# **Sanitize Device Command**

**May 28, 2009**

**Revision 8**

## 4. Changes to ACS-2

Figure xx – SANITIZE DEVICE State Machine

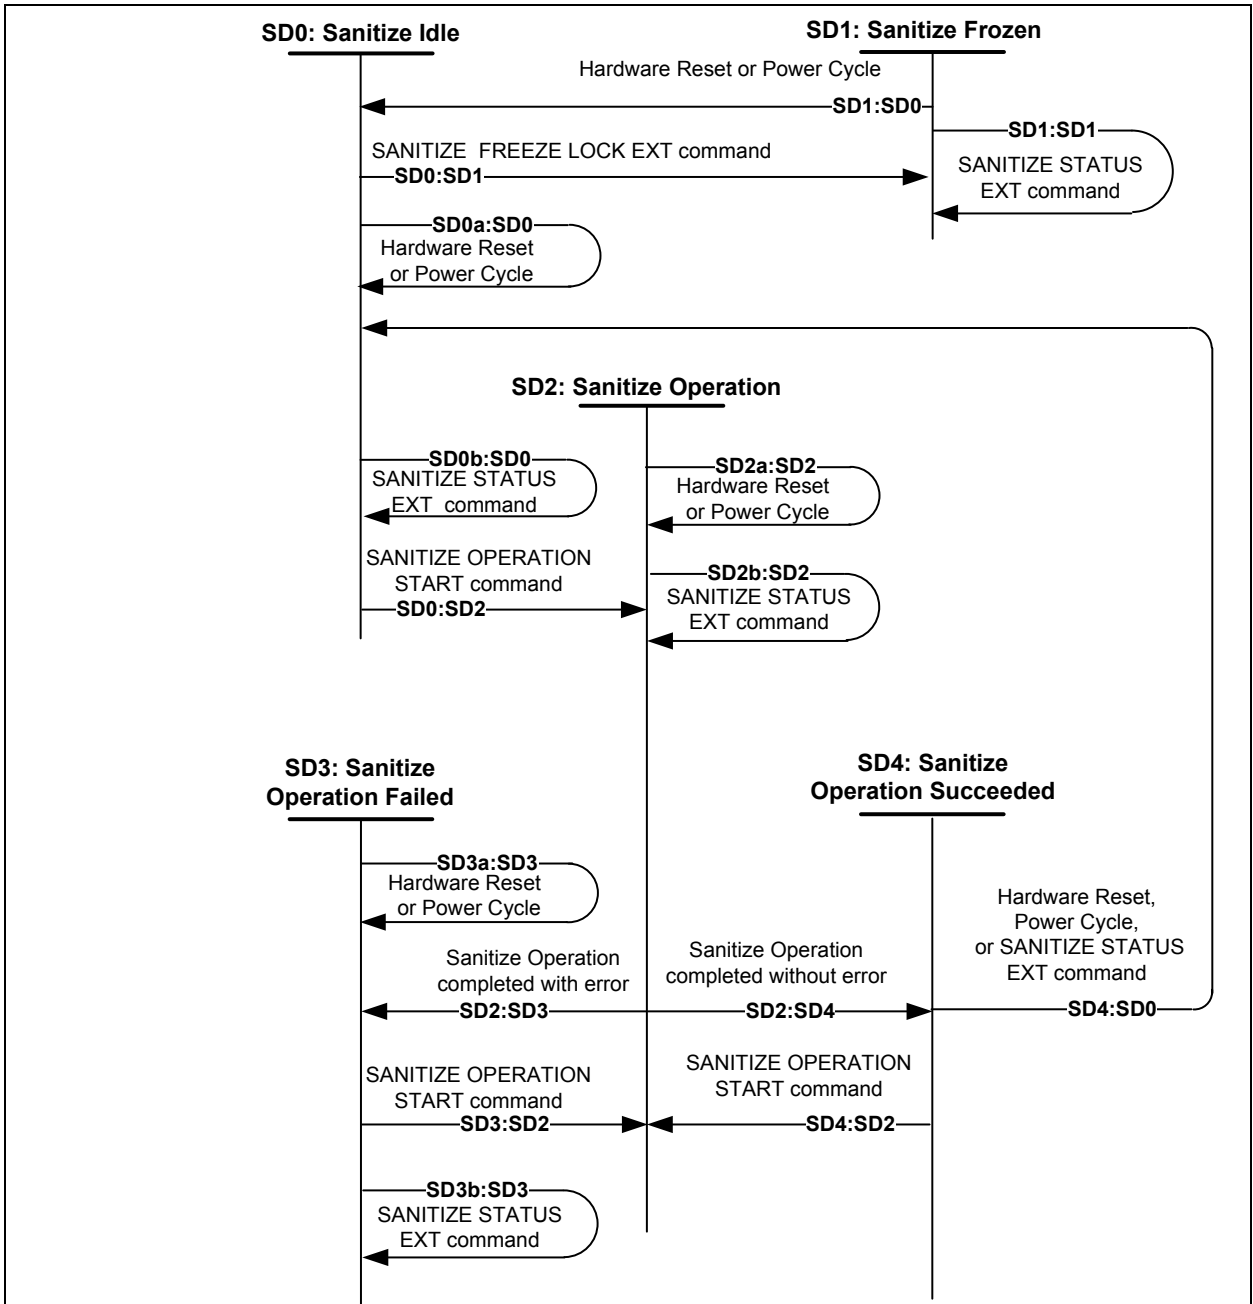
Figure xx and the text in this subclause describe the operation of the Sanitize Device Feature set.

**SD0: Sanitize Idle State:** This state is entered when the device processes a power cycle from SD0, SD1 or SD4.

**Transition SD0a:SD0:** When the device is in the Sanitize Idle state and it processes a hardware reset or power-on reset, the device shall remain in the SD0 Sanitize Idle state.

**Transition SD0b:SD0:** When the device is in the Sanitize Idle state and it processes a SANITIZE STATUS command, the device shall complete the command and remain in the SD0 Sanitize Idle state.

**Transition SD0:SD1:** When the device is in the Sanitize Idle state and it processes a SANITIZE FREEZE LOCK EXT command, the device shall transition to the SD1 Sanitize Frozen state.

**Transition SD0:SD2:** When the device is in the Sanitize Idle state and it processes a supported SANITIZE OPERATION START command, the device shall transition to the SD2 Sanitize Operation state.

**SD1: Sanitize Frozen State:** This state is entered from the SD0 Sanitize Idle state when the device processes a SANITIZE FREEZE LOCK EXT command.

**Transition SD1:SD0:** When the device is in the Sanitize Frozen state and it processes a hardware reset or a power cycle, the device shall transition to the SD0 Sanitize Idle state.

**Transition SD1:SD1:** When the device is in the Sanitize Frozen state and it processes a SANITIZE STATUS EXT command, the device shall complete the command and remain in the SD1 Sanitize Frozen state.

**SD2: Sanitize Operation State:** This state is entered when:

- a) the device processes a power cycle from SD2; or
- b) the device is in the SD0 Sanitize Idle state and a supported SANITIZE OPERATION START command is received.

**Transition SD2a:SD2:** When the device is in the Sanitize Operation state and it processes a hardware reset or power cycle, the device shall remain in the SD2 Sanitize Operation state.

**Transition SD2b:SD2:** When the device is in the Sanitize Operation state and it processes a SANITIZE STATUS EXT command, the device shall remain in the SD2 Sanitize Operation state.

**Transition SD2:SD3:** When the device is in the Sanitize Operation state and a Sanitize Operation completes with an error, the device shall transition to the SD3 Sanitize Operation Failed state.

**Transition SD2:SD4:** When the device is in the Sanitize Operation state and a Sanitize Operation completes without an error, the device shall transition to the SD4 Sanitize Operation Succeeded state.

**SD3: Sanitize Operation Failed State:** This state is entered when:

- a) the device processes a power cycle from SD3; or
- b) the device is in the SD2 Sanitize Operation state and a Sanitize Operation completes with an error.

**Transition SD3a:SD3:** When the device is in the Sanitize Operation state and it processes a hardware reset or a power cycle, the device shall remain in the SD3 Sanitize Operation state.

**Transition SD3b:SD2:** When the device is in the Sanitize Operation state and it processes a SANITIZE STATUS EXT command, the device shall remain in the SD2 Sanitize Operation state.

**Transition SD3:SD2:** When the device is in the Sanitize Operation state and it processes a supported SANITIZE OPERATION START command, the device shall transition to the SD2 Sanitize Operation state.

**SD4: Sanitize Operation Succeeded State:** This state is entered when the device is in the SD2 Sanitize Operation state and a Sanitize Operation completes without an error.

**Transition SD4:SD0:** When the device is in the Sanitize Operation state and it processes

- a) a hardware reset;
- b) a power cycle or
- c) a SANITIZE STATUS EXT command

the device shall transition to the SD0 Sanitize Idle state.

**Transition SD4:SD2:** When the device is in the Sanitize Operation state and it processes a supported SANITIZE OPERATION START command, the device shall transition to the SD2 Sanitize Operation state.
